Mobile Intel[®] Pentium[®] 4 Processor-M

Specification Update

September 2004

Document Number: [250721-025](#)

Figure 13. System Bus Reset and Configuration Timings

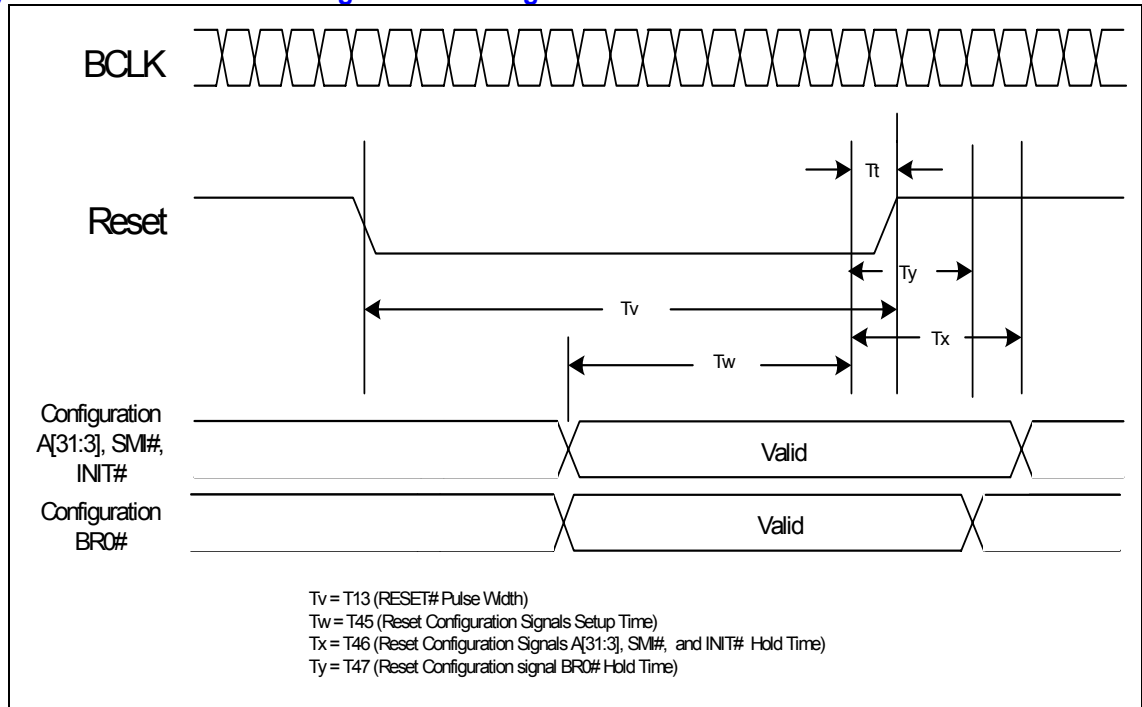
T2. BR0# Maximum Hold Time Specification Change

The BR0# maximum hold time has changed to 2 BCLKs. This change will be shown in the “System Bus AC Specifications (Reset Conditions)” table and “System Bus Reset and Configuration Timings” figure of the *Mobile Intel® Pentium® 4 Processor - M Datasheet*. This change will be incorporated in the next revision of the datasheet.

The following figure will be modified to reflect this change:

T# Parameter	Min	Max	Unit	Figure	Notes
T45: Reset Configuration Signals (A[31:3]#, BR0# INIT#, SMI#) Setup Time	4		BCLKs	13	1
T46: Reset Configuration Signals (A[31:3]#, INIT#, SMI#) Hold Time	2	20	BCLKs	13	2
T47: Reset Configuration Signal BR0# Hold Time	2	2	BCLKs	13	2

1. Before the deassertion of RESET#.
2. After clock that deasserts RESET#.
